October 25, 2019

Product Change Notice - Second vendor for hydraulic valves

Fig.1

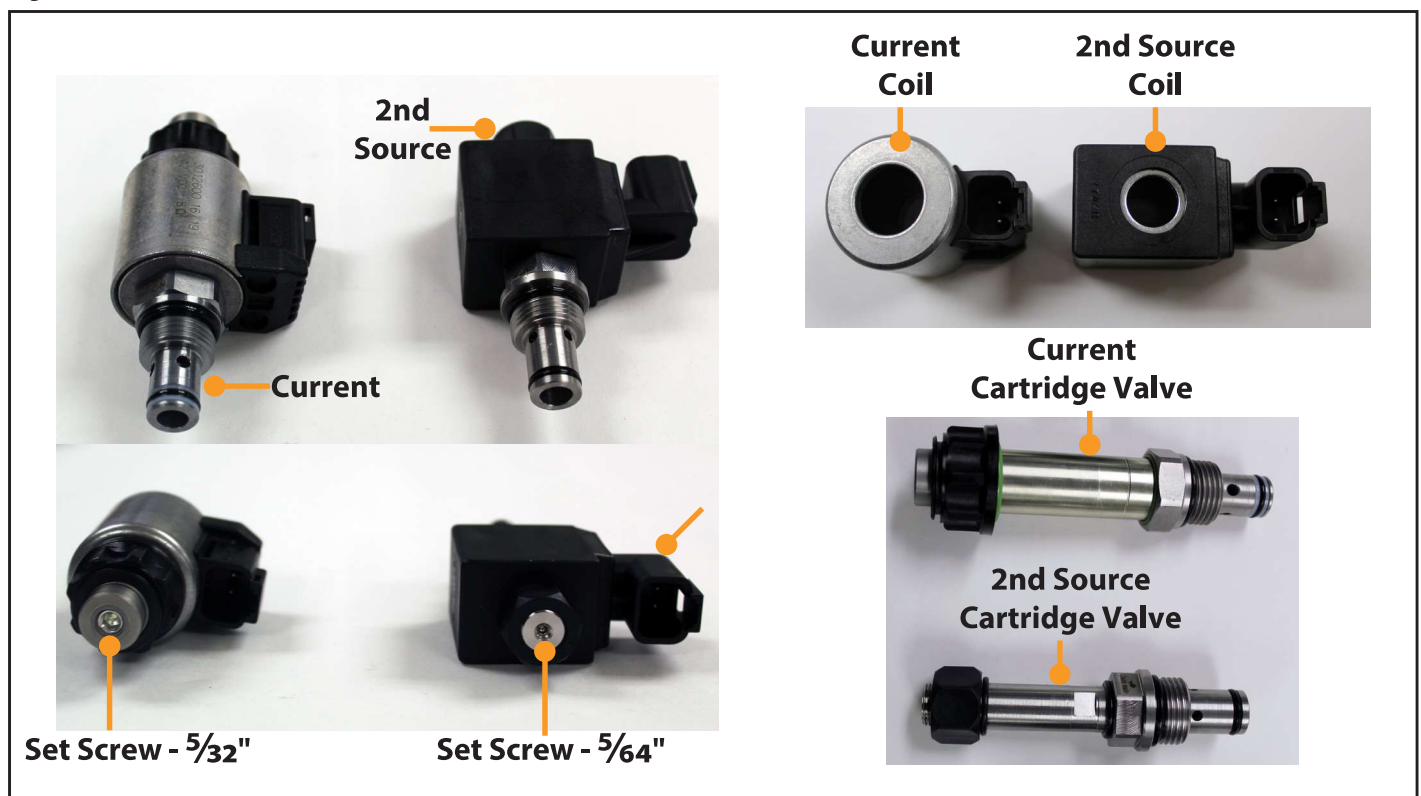
The current and second source valves are visibly different (Fig. 1) but they install the same way. The only difference in operation is the cartridge valve manual override screw size — the current source is 5/32" and second source is 5/64".

The OEM leveling kits will contain all current source or all second source components - the two sources will not be mixed in a kit. The cartridge valve and spade coils are shipped unassembled. The cartridge valve/coils are not interchangeable between the two sources for service/replacement (PN 176954 must be used with PN 177094, and PN 80119 with PN 80112.)
